Your ref: DOC22/1089216-3
Our ref: PP-2022-3978

EPA Response to draft Gilead Part Precinct Structure Plan

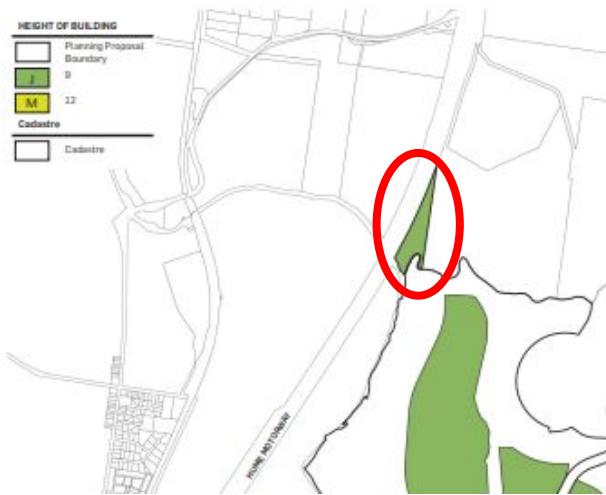
Based on our review of the Precinct Area, a triangular piece of land within the north-western section of the Precinct (outlined in the diagram below in red) with a proposed building height of 9 metres is located directly adjacent to the Hume Motorway. Attended noise monitoring was completed for this location but noise mitigation measures for these future residents were not considered in the Noise Assessment.

The EPA recommends that noise mitigation measures for future residents located in the north-western section of the Precinct be included in the final structure plan for Gilead.
